## Morecambe Offshore Windfarm: Generation Assets Procedural Deadline A

### The Applicant's Response to Relevant Representations

Document Reference: 8.3

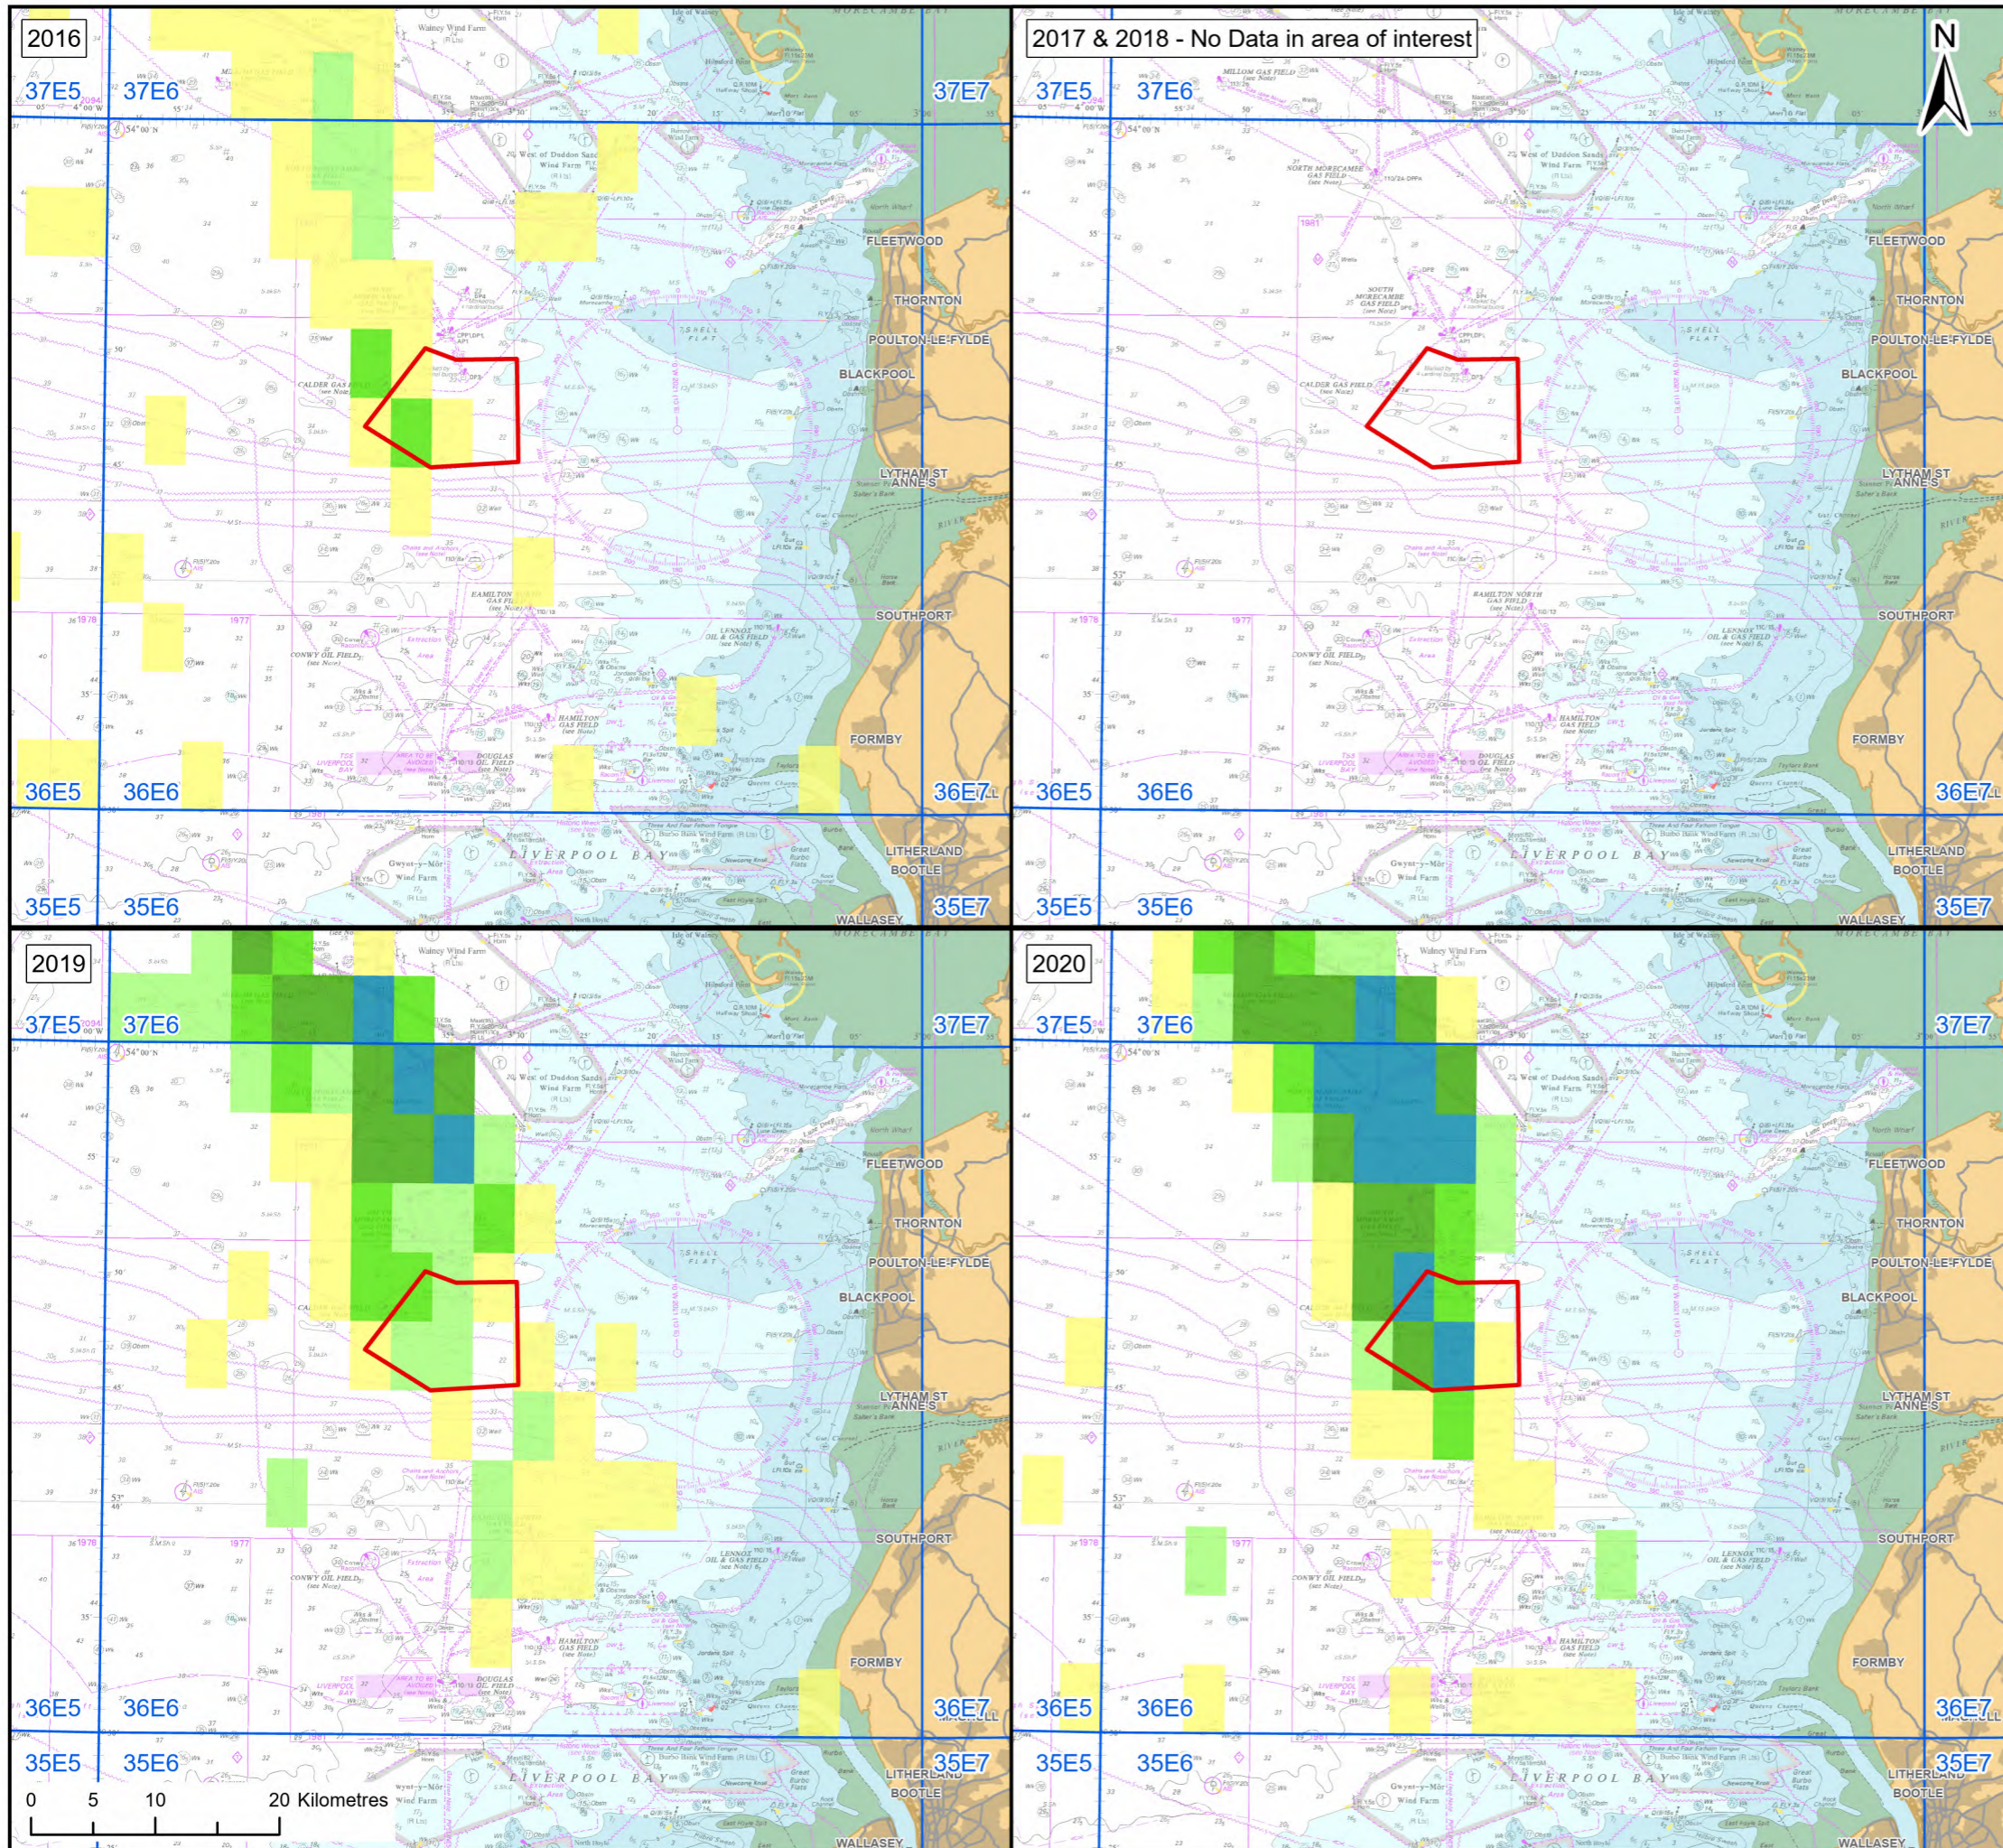
ID	RR	Applicant's Response
		<p><b>Figure 2b</b> below this RR response. The data further demonstrates the higher intensity activity to the north and north-west of the Project. Based on analysis of the fishing effort within 36E6 on average, approximately 8% of the EU (including UK) beam trawl fishing intensity within 36E6 occurs within the Project boundaries (based on a 9 year average from 2012 and 2020).</p> <p>As secured by the Fisheries Co-existence and Liaison Plan (FLCP), with an outline submitted within the Development Consent Order (DCO) Application (APP-147), the Applicant is committed to updating the fishing industry, including Rederscentrale, on the timing and location of any construction works. Fishers would not be prohibited from entering the site, with exception of Safety Zones around infrastructure under construction and major maintenance activities.</p> <p>The Applicant considers the impact assessment and conclusions for the Belgian beam trawl fleet to remain valid, as set out in Chapter 13 Commercial Fisheries (APP-050).</p> <p>The Applicant would welcome further data on the Belgian beam trawl spatial activity and landings. While landings data for period 2012 to 2016 is recognised as historic (landings data for non-UK vessels was not available post-2016 by ICES rectangle), it has been supplemented with spatial VMS data up to 2020.</p>
